**COMMENT RESPONSE DOCUMENT (CRD)
TO NOTICE OF PROPOSED AMENDMENT (NPA) 2009-07**

**for amending the Executive Director Decision No 2003/02/RM of 17 October 2003
on certification specifications, including airworthiness codes and acceptable means
of compliance, for large aeroplanes (« CS-25 »)**

'Security related design standards'

Attachment #3 to comment #24

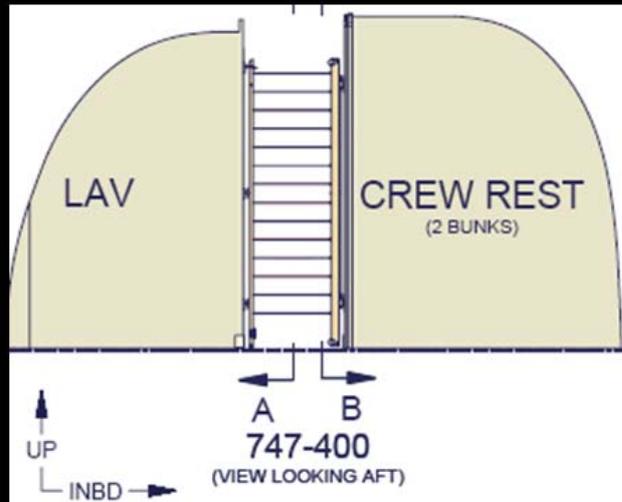
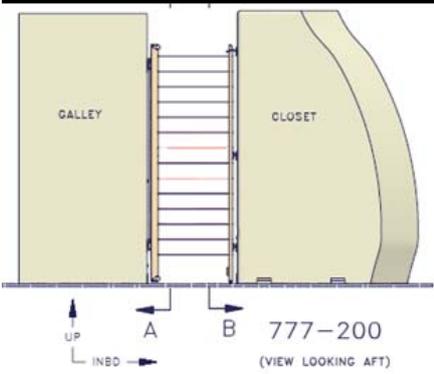
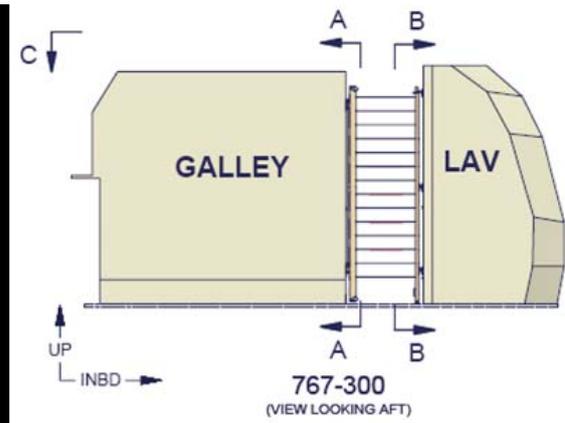
comment	24	comment by: <i>ECA- European Cockpit Association</i>
	Attachment #3	
	<p><u>ECA proposed comment: renumber and add paragraph:</u></p> <p>CS 25.795 (a) <u>Protection of the flight deck</u></p> <p><u>(1) Protection of secure doors: the bulkhead, door, and any other accessible boundary separating the flightcrew compartment from occupied areas installation must be designed to:</u></p> <p>(1)(i) Resist forcible intrusion by unauthorized persons and be capable of withstanding impacts of 300 Joules (221.3 footpounds) at the critical locations on the door , as well as a 1113 Newton (250 pound) constant tensile load on accessible handholds, including the doorknob or handle (See AMC 25.795(a)(1)), and</p> <p>(2)(ii) Resist penetration by small arms fire and fragmentation devices by meeting the following projectile definitions and projectile speeds (See AMC 25.795(a)(2)).</p> <p>(i)(a) Demonstration Projectile #1. A 9 mm full metal jacket, round nose (FMJ RN) bullet with nominal mass of 8.0 g (124 grain) and reference velocity 436 m/s (1430 ft/s)</p> <p>(ii)(b) Demonstration Projectile #2. A .44 Magnum, jacketed hollow point (JHP) bullet with nominal mass of 15.6 g (240 grain) and reference velocity 436 m/s (1430 ft/s)</p> <p><u>(iii) The flight deck door lock should be operable from the pilot's station</u></p> <p><u>(2) Protection of the secondary barrier: A Secondary Barrier system should have the ability to delay and deter potential assailant from entering the flight deck from the cabin area during this period of "door</u></p>

<p><u>transition,” which can be defined as that period of time when the flight deck door remains open due to operational needs and/or crew requirements. Five seconds is considered a reasonable amount of time for “door transition”.</u></p> <p><u>Justification</u> Flight decks remain vulnerable, especially when the doors are opened for normal/legitimate reasons. The best example is the unlawful interference in Turkish Airlines flight TAL 1476. The report of the Captain reads: <i>“While the chief stewardess entered the cockpit to ask if we needed anything, the terrorist entered by force. I tried to push him out, but he was a big man and I failed to stop him”</i> The flight deck door needs to be open to grant access to the cockpit, to allow exit and to exchange objects and information. Opening the flight deck door constitutes a possibility for an attempt of unlawful access to the cockpit. The goal of secondary barriers is to protect the cockpit during flight deck door transitions. Secondary Barriers should respond to the following criteria: – 5 Second delay – Ease of use – Egress in case of emergency evacuation – Clear field of view for crew Combined with appropriate procedures, the secondary barrier is a pre-emptive solution and a deterrent for unlawful attempts to enter the cockpit. It creates a secured buffer zone, and allows the crews to assess the intentions of persons trespassing the barrier and gain precious seconds to secure the cockpit. Attached: Examples of secondary barriers on board of United Airlines' aircraft.</p>

response	<i>Not accepted</i>
----------	---------------------

<p>First of all, this requirement is outside the remit of our task which is limited to harmonising with FAR 25.795. So the proposed rule will not be up-dated to take into account this secondary barrier.</p> <p>For your information, this subject was debated already at FAA and the Agency decided to follow FAA decision. Currently the secondary barrier is indeed not seen as a contributor to flight deck security as required by FAR 25.795 but more as a supplemental security measure intended to complement existing flight deck door access procedures (refer to FAR 121.584 (a) (1) and OPS 1.1255)</p> <p>In conclusion, there is no intention to mandate any secondary barrier. The idea is more to ensure safety of the flight deck thanks to operational procedures.</p>
--	---
